Technical Bulletin: eSet® Liners for Pro Series Style meters

January 17, 2011

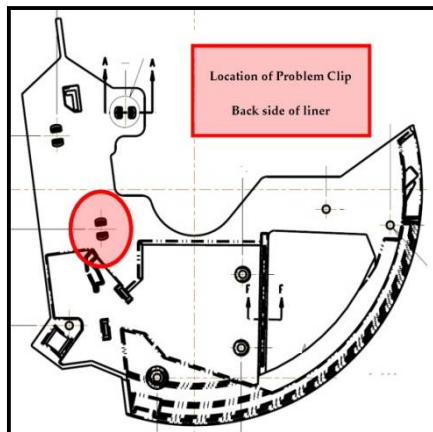
Problem: Due to a failure in our production mold, one batch of eSet liners for Pro Series meters has a molded clip with a deformed prong. This prevents the clip from locking into the housing.

Details: The deformed clip is easily identified. As shown below, just look at the back of the liner and locate the clips highlighted in the drawing.

The tabs should look like the ones in this picture.

The deformed tabs have a solid base that will prevent them from clipping into the liner as shown here.

Precision Planting Resolution: While we have identified that there were over 3,000 liners in the batch, we just recently began shipping from this batch. We have quarantined these liners, but it looks like about 900 of suspect liners may have shipped over the last few weeks.

We will ship replacement liners as soon the mold is fixed and they can shoot new liners – probably two weeks.

Please inspect your eSet kits and use the form on the back of this bulletin to let us know how many you need for replacement. We do not need the defective liners back . . . we just ask that you destroy them.
